Application ref: EN010147

Application by Photovolt Development Partners (PVDP) on behalf of SolarFive Ltd (the Applicant) for a Development Consent Order for Botley West Solar Farm

Notification of Intention to Submit a Request to Change the Application (Change Request 2)

Notification - Change 5

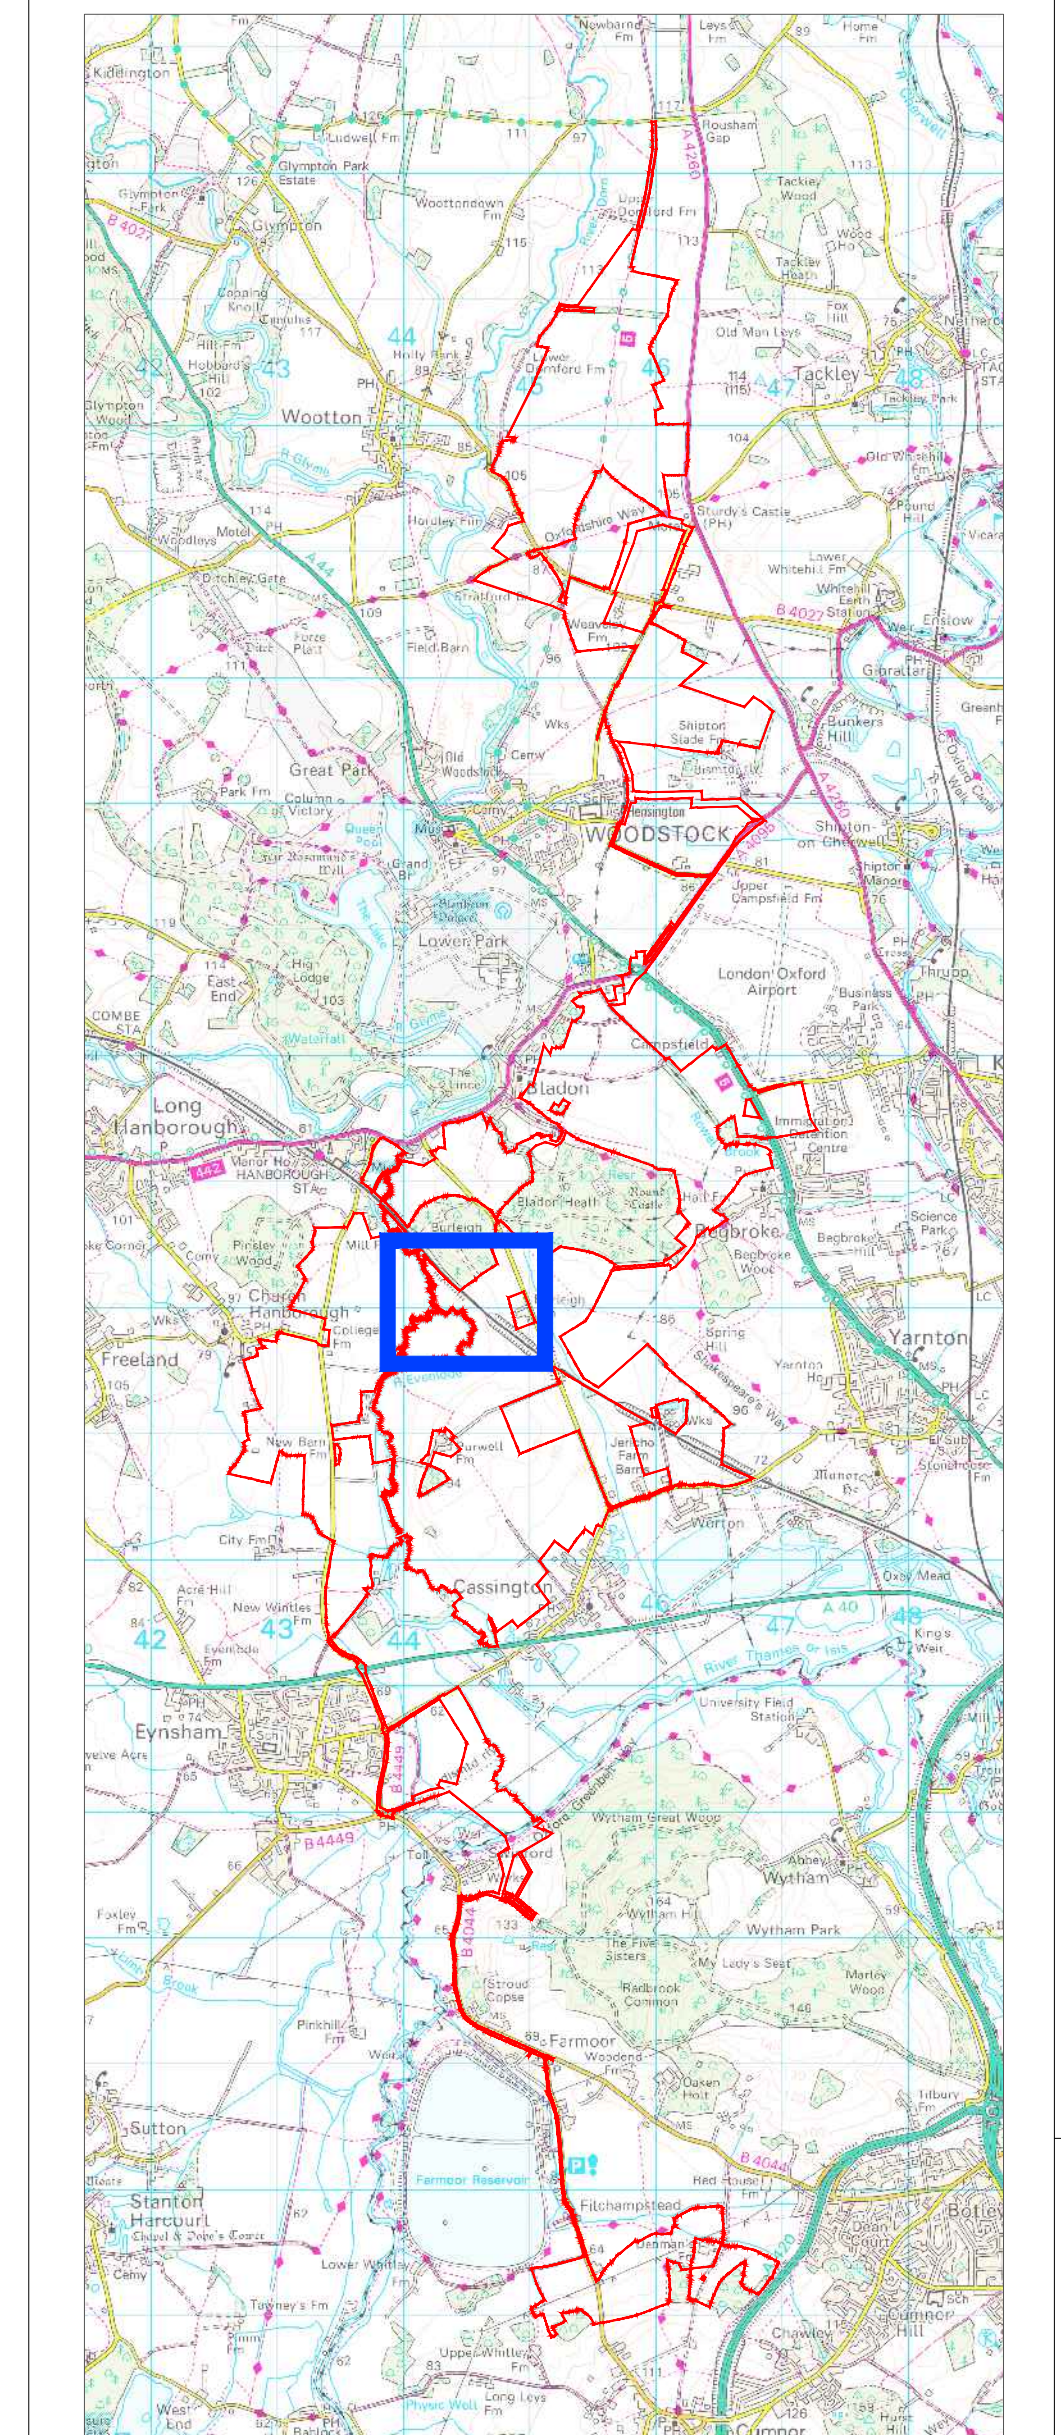
(3) Remove solar installation area for further flood zone protection and management (0.0066ha)

(4) Remove solar installation area for further flood zone protection and management (0.43ha)

Title: Change Request 2
Notification - Change 5

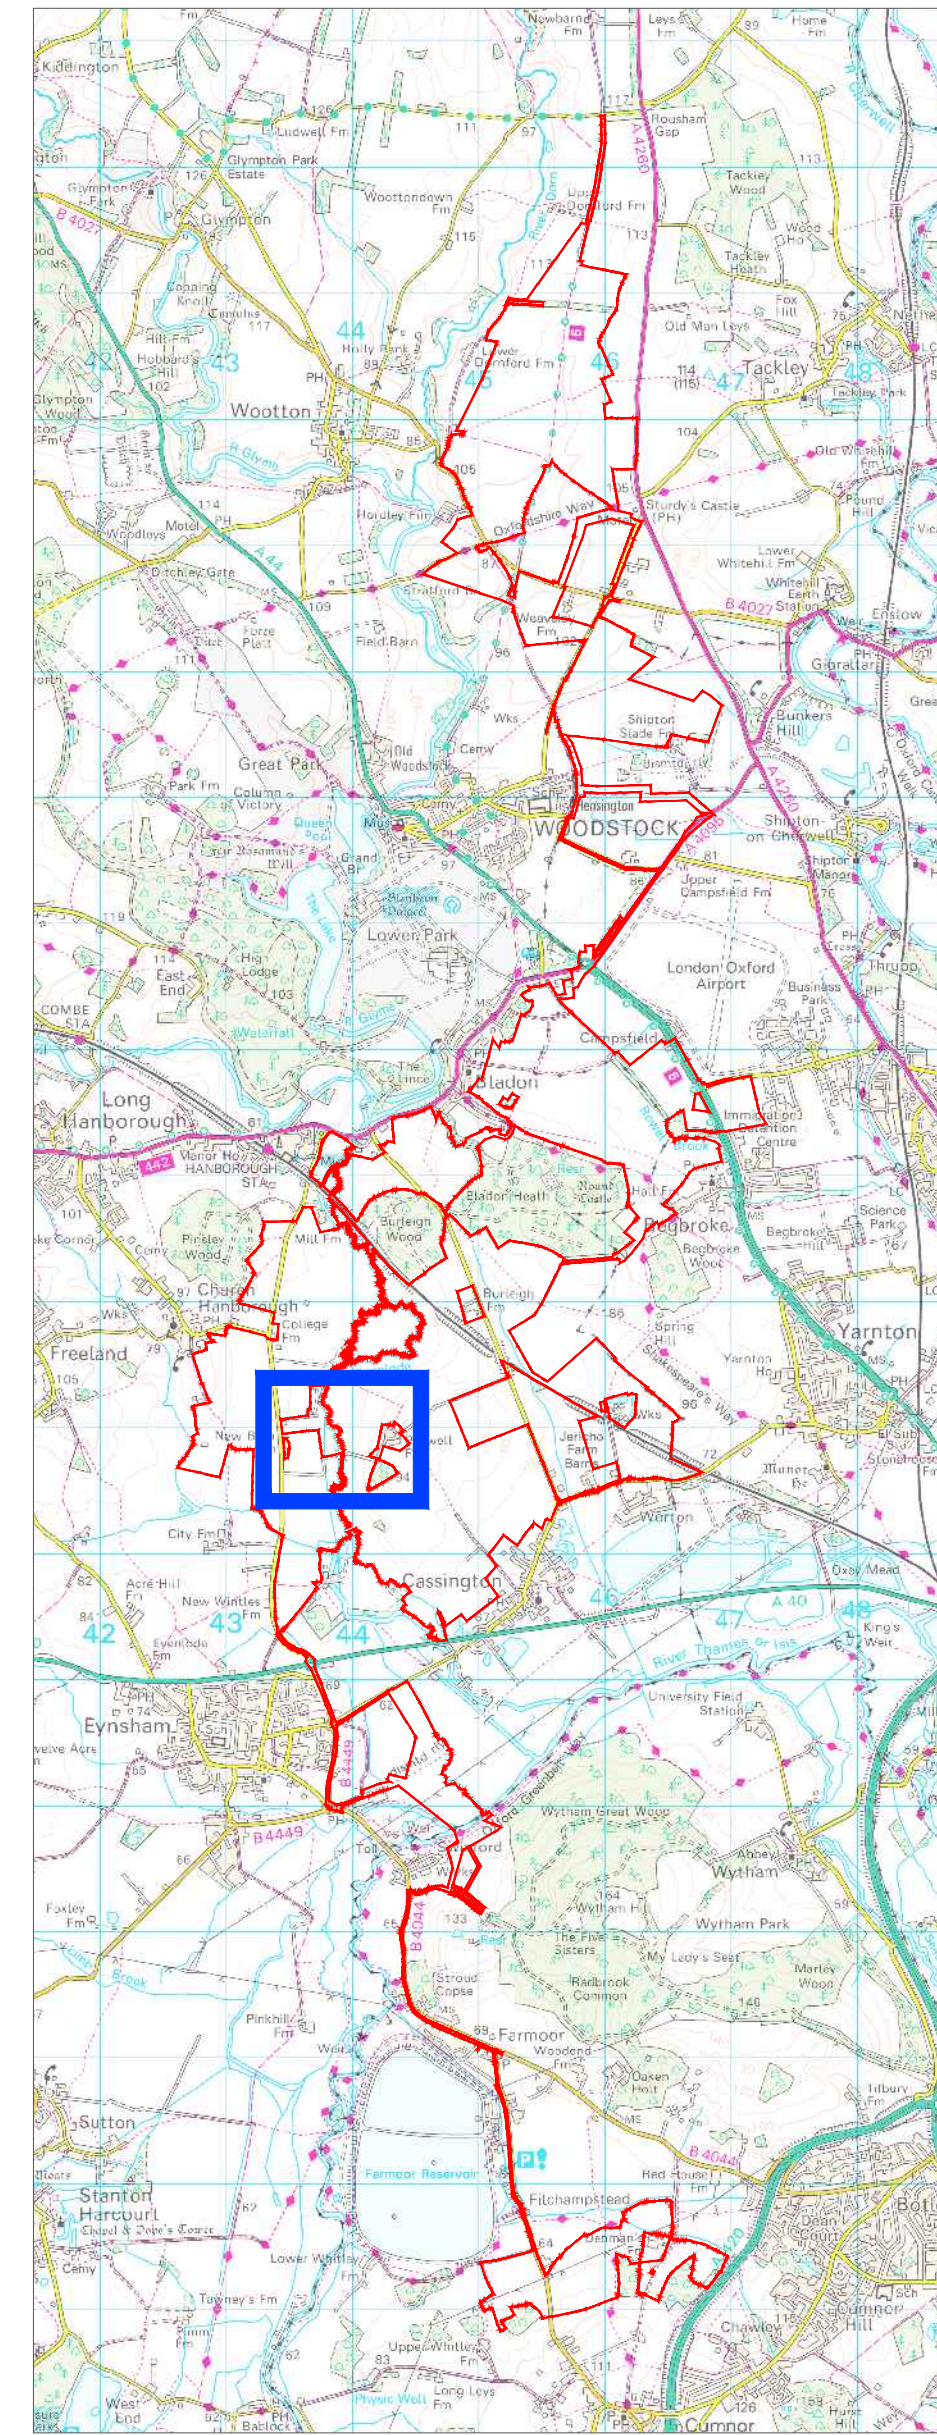
- Legend
- RLB of the S51 response
- Proposed Infrastructure and Land Use Elements *
- Solar Panels
- Maintenance Road
- Fence
- Access Gate
- PCS
- Indicative 33kV Cable Route
- Project Refinements
- (5) Replace solar installation area for further archeological protection and management (0.0048ha)

Title Change Request 2
Notification - Change 5

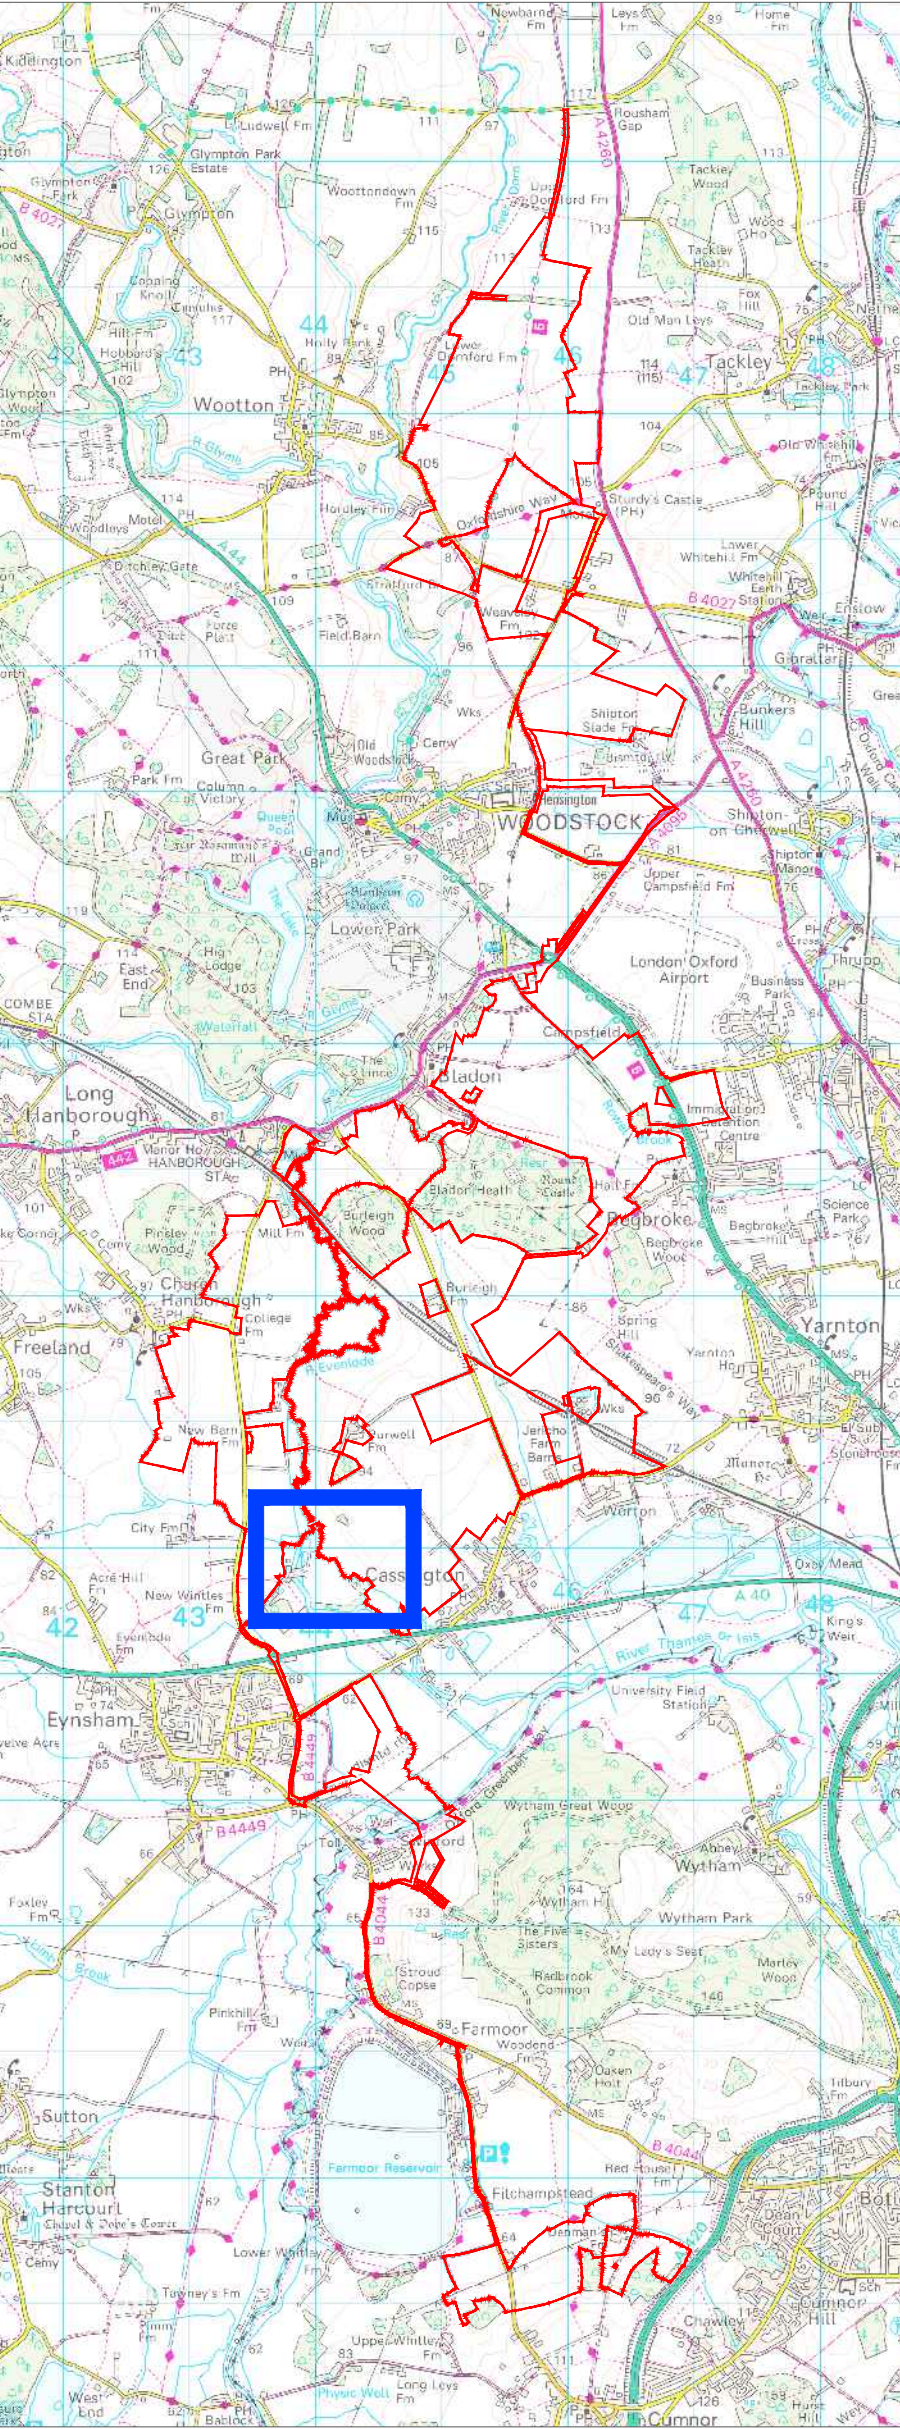
(6) Replace solar installation area for further archeological protection and management (0.016ha)

(7) Replace solar installation area for further archeological protection and management (0.0048ha)

Scale:	1:1250	at A0
Title		
Change Request 2		
Notification - Change 5

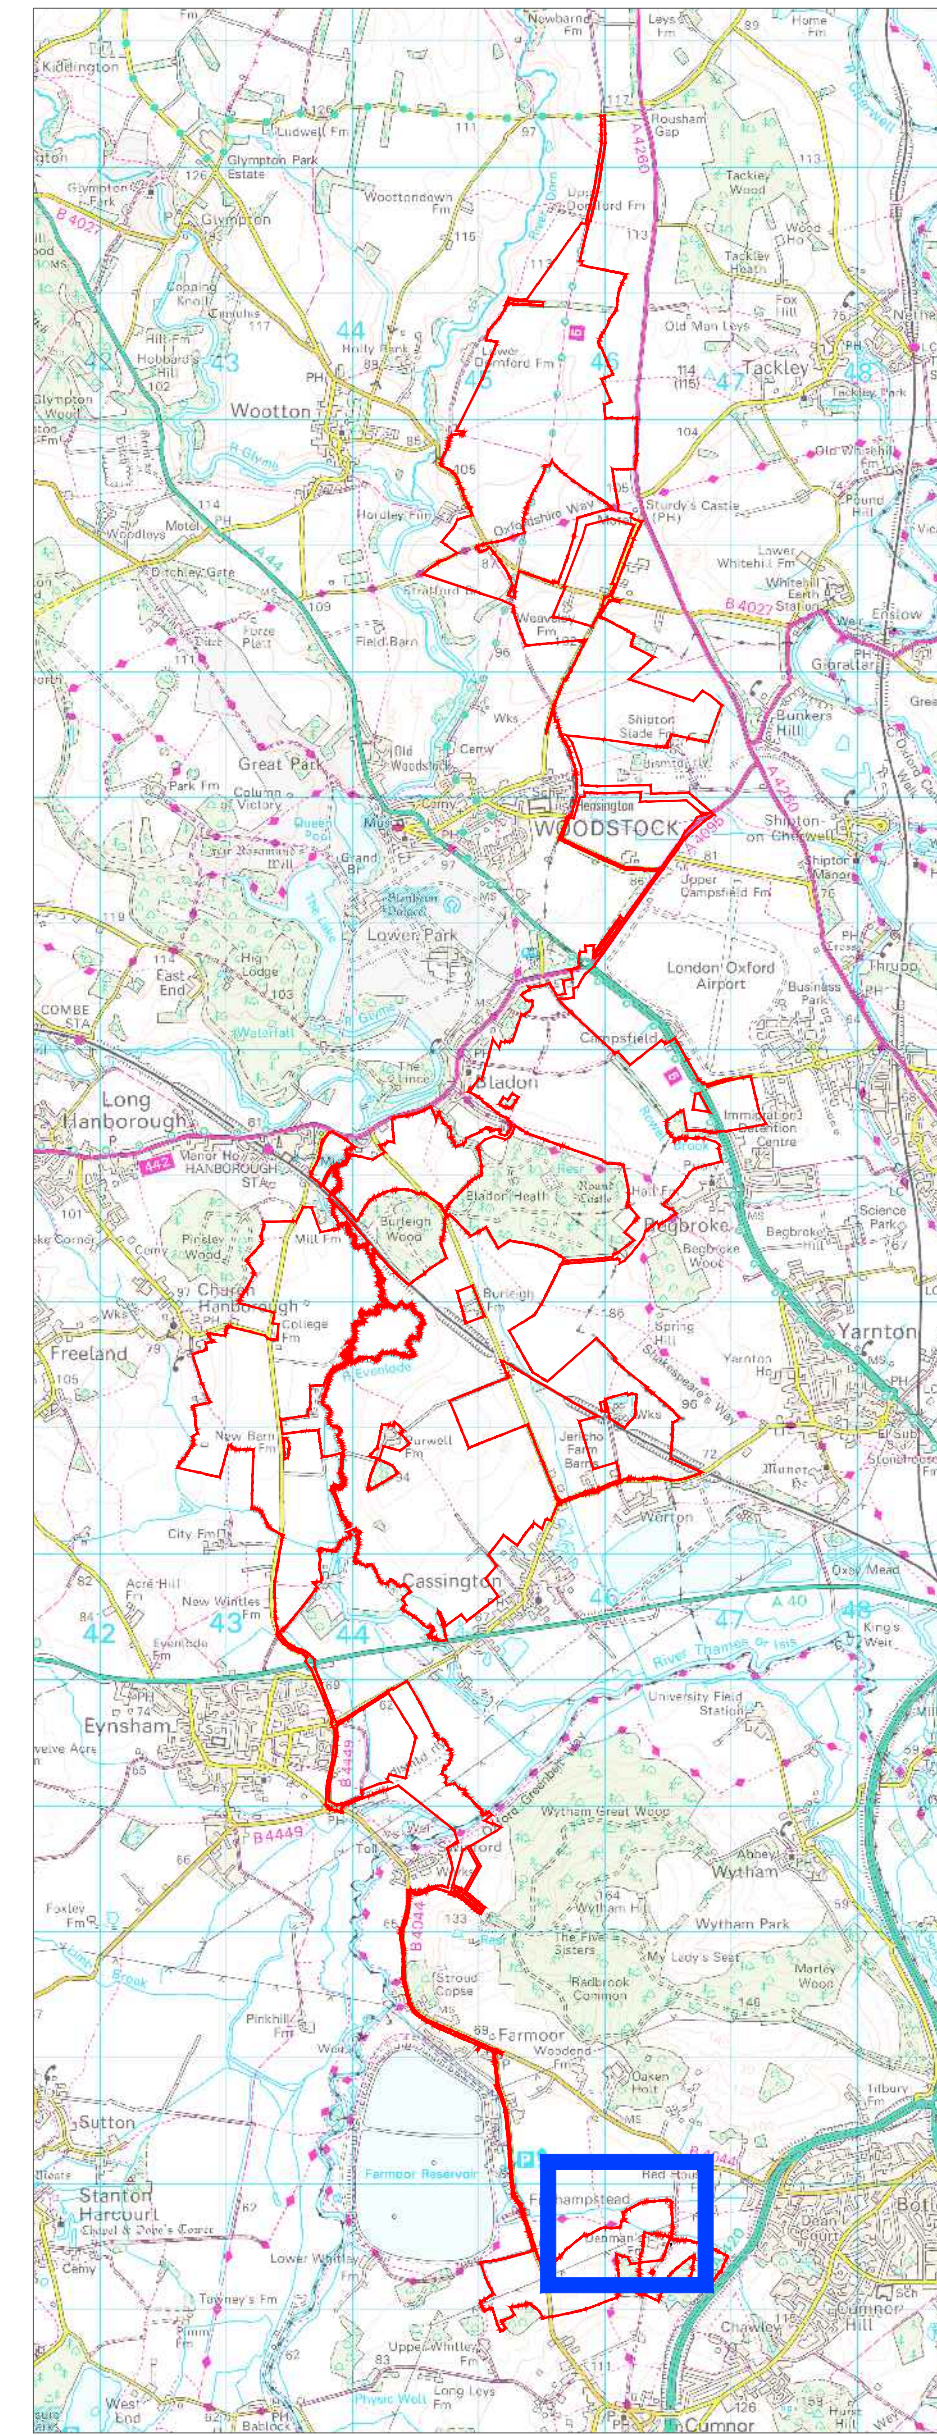
(9) Remove solar installation area for further flood zone protection and management (0.064ha)
